Great North Road Solar and Biodiversity Park

Responses to ExA's Second Written Questions

Document Reference - EN010162/APP/8.30

Figure 1: PEIR Boundary, Work Areas and Geophysical Survey Extent

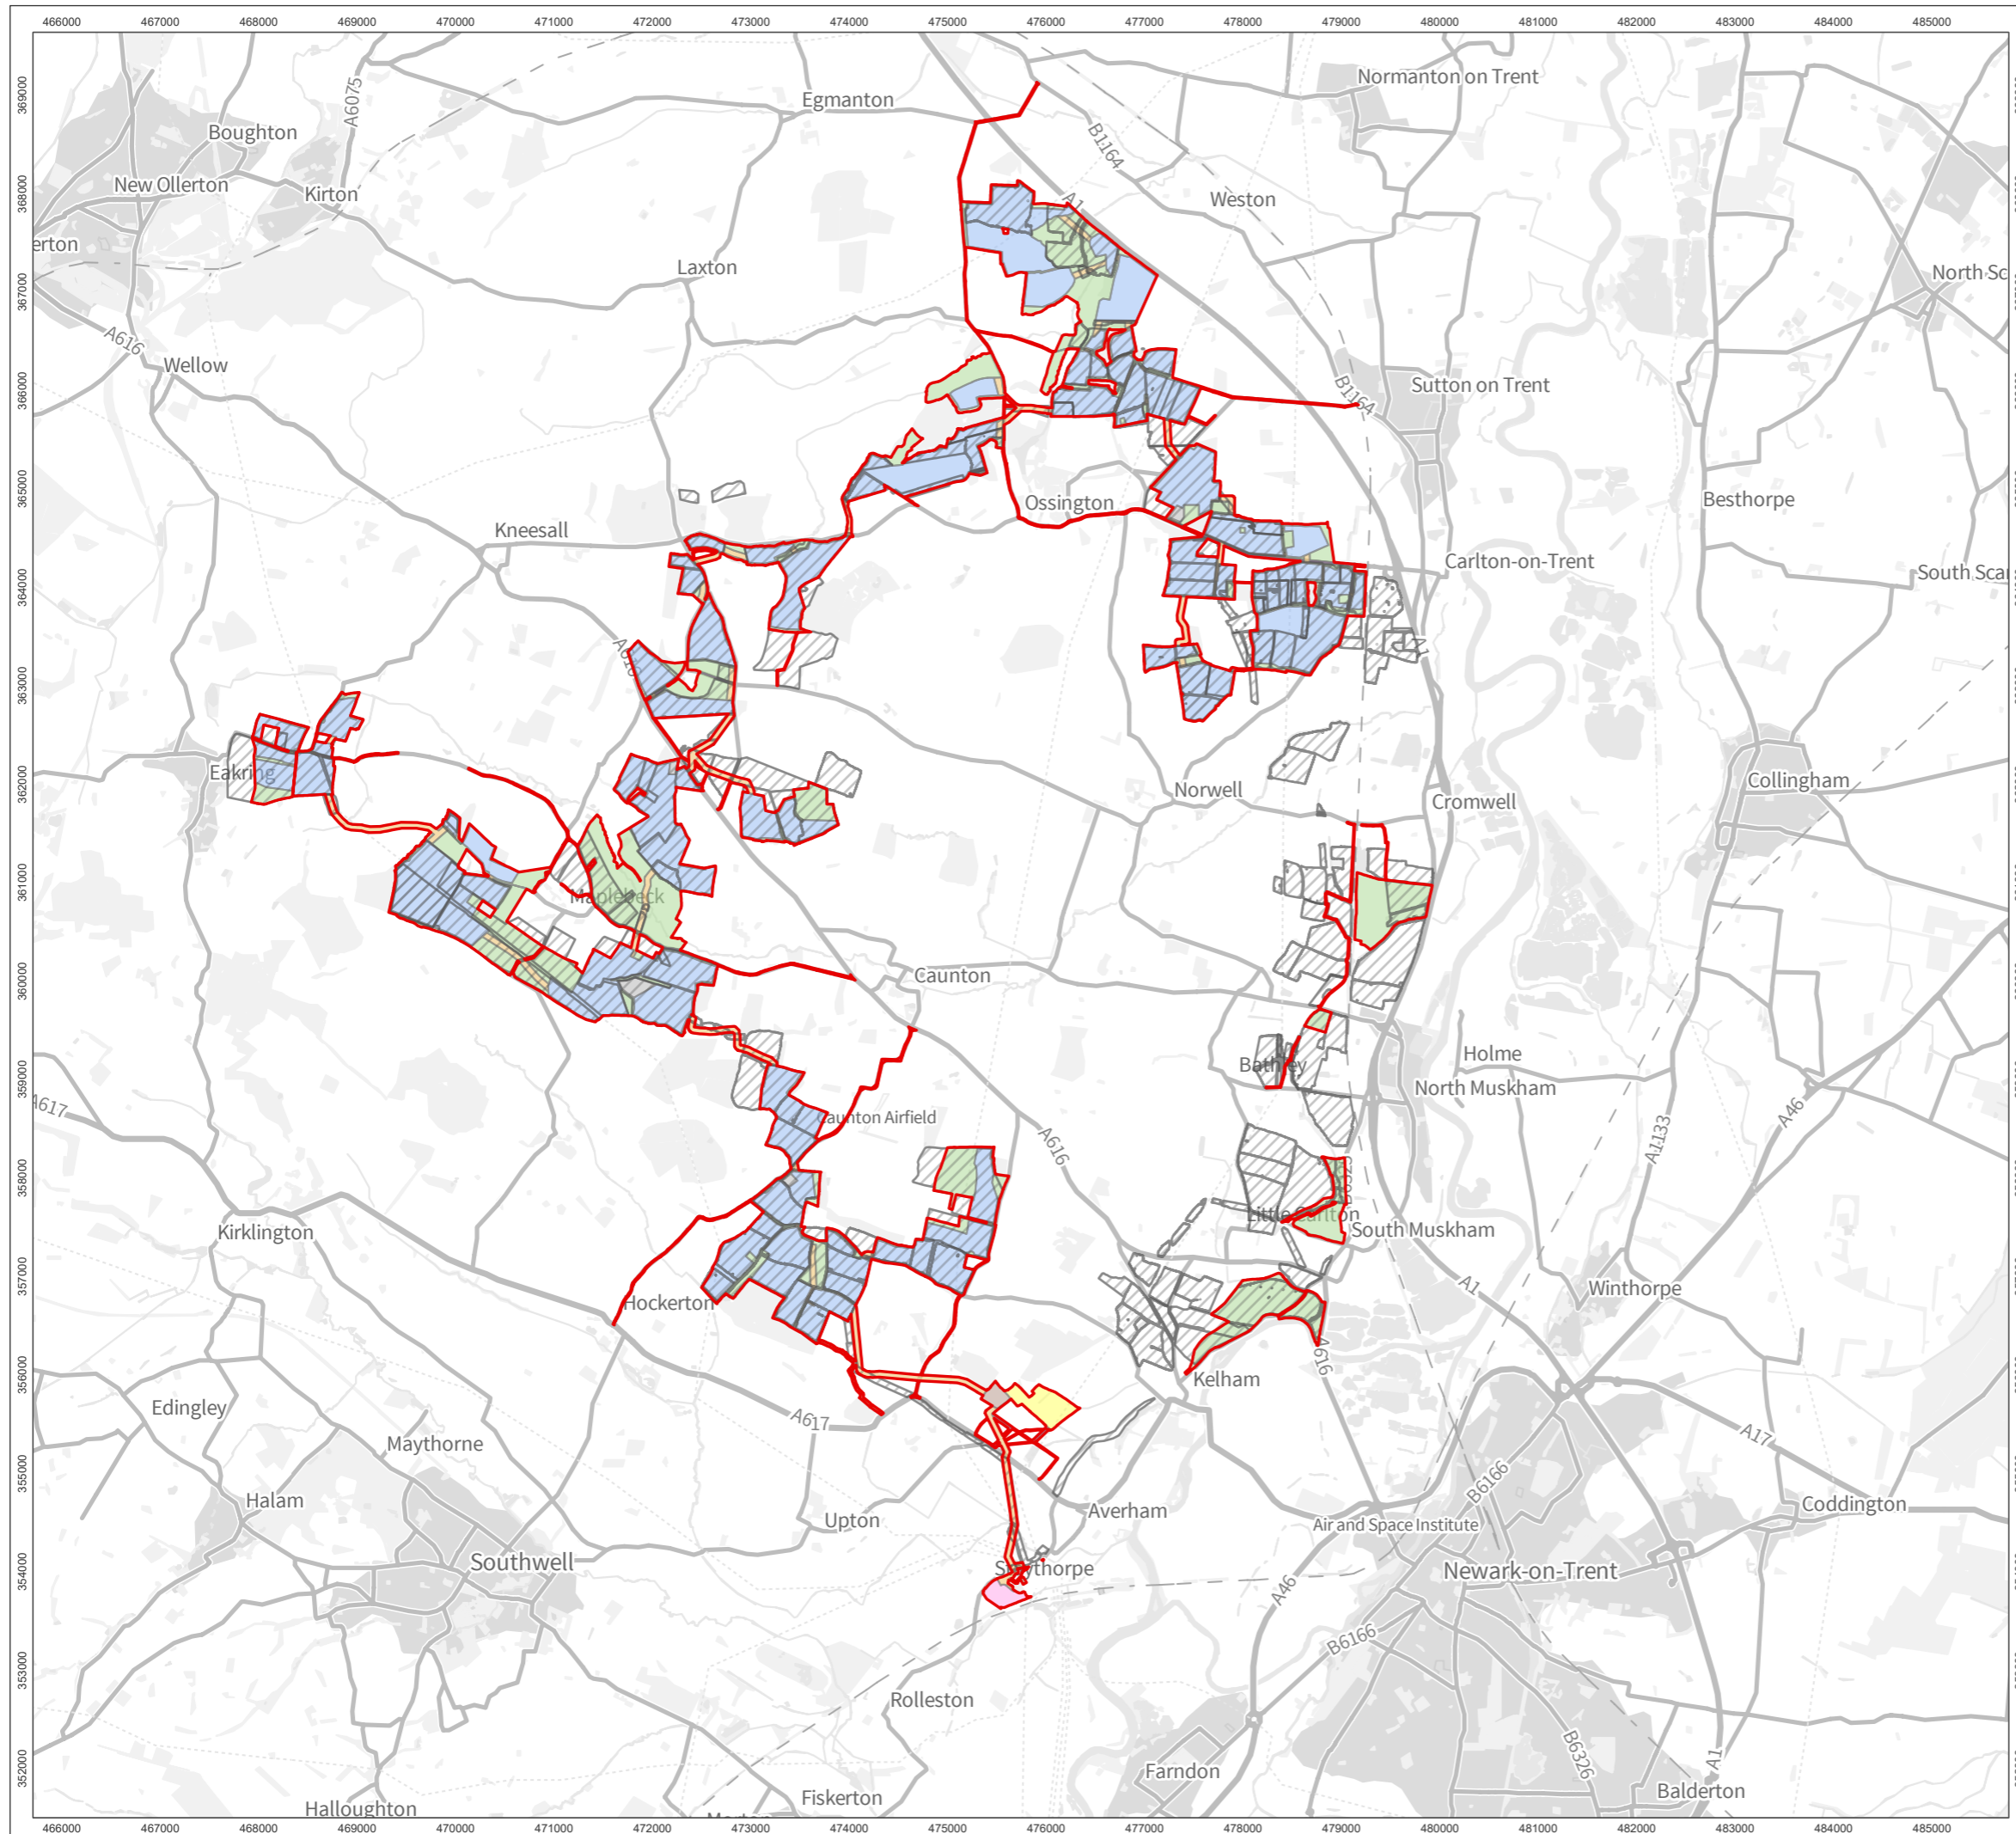
ExQ2 Ref	Question to:	Question	Applicant's Responses
		<p><i>is based on a somewhat limited understanding of the nature of the archaeological record, on the basis of limited ground-truthing through trial trench evaluation.'</i></p> <p>Noting that the SoCG with HE [REP3-077] suggests that all archaeological matters have been agreed, the ExA would welcome further clarity HE's position on this point, including:</p> <ol style="list-style-type: none"> a. Clarity on where any incongruity lies b. Whether post-consent works could address any concerns about the inadequacy of investigations to date. 	<p>outlines the geophysical survey at the PIER boundary and the Order Limits.</p> <p>The scope of post-consent investigation, provision for which is set out in the ES Volume 4, Appendix A11.8: Outline Archaeological Mitigation Strategy (AMS) [EN010162/APP/6.4.11.8C], will be agreed through continued engagement with NCC during the period of the examination. As noted at row 2.1.3 of the Draft Statement of Common Ground with Historic England [EN010162/APP/8.5C], the Applicant understands that HE are content to leave the detail of the ES Volume 4, Appendix A11.8: Outline AMS [EN010162/APP/6.4.11.8C] for NCC and the Applicant to agree.</p>

ExQ2 Ref	Question to:	Question	Applicant's Responses
			<p>In response to (c), the Applicant does not accept the heritage report's findings and considers that there is no harm to the interest from which this non-designated asset's significance is derived, as the current setting beyond the immediate curtilage does not contribute significantly to how those interests can be understood and appreciated. A detailed responses to point (c) is provided at paragraph 9.17 to 9.22.</p>
Q8.2.4	The applicant and HE	<p>Adequacy of pre-consent archaeological assessment</p> <p>ExQ 8.1.2 sought parties views on the whether the basis of the applicant's archaeological mitigation strategy is reasonable, noting that it is suggested that it could progress on a precautionary basis, assuming a reasonable worst case scenario, as the conclusions of the archaeological desk-based assessments are predicative and probabilistic and the results of the geophysical surveys have not been ground-truthed in their entirety.</p> <p>In HE's response it was suggested that this approach should also be applied where <i>'non-intrusive geophysical survey or trial trench evaluation has not been completed; there appears to be a slight incongruousness to the overall approach in the way. It's useful to note that while an application of professional judgement is wholly reasonable, this judgement</i></p>	<p>The HE confirmed to the Applicant that the method and assessment of significance is an agreed matter, and that HE had no further comment to make. This is the position set out in the Draft Statement of Common Ground with Historic England [EN010162/APP/8.5C]. In response to this question, Applicant has sought to engage with the HE on multiple occasions, but is awaiting a reply from HE.</p> <p>In response to point (b), the Applicant's understanding is that HE accepts that an appropriate programme of post-consent work can address any concerns HE still has. In terms of the completeness of survey to date it should be noted that geophysical baseline survey coverage was c.73% across the Order Limits with c.90% coverage of Works Area 1 Solar and that trenching tested all geologies. The pre-consent archaeological assessment is therefore considered to be proportionate, in line with developing best practice guidelines and sufficient to inform the ES Volume 2, Chapter 11: Cultural Heritage and Archaeology [EN010162/APP/6.2.11] [APP-054]. Please refer to Appendix 1 of this Report, which</p>
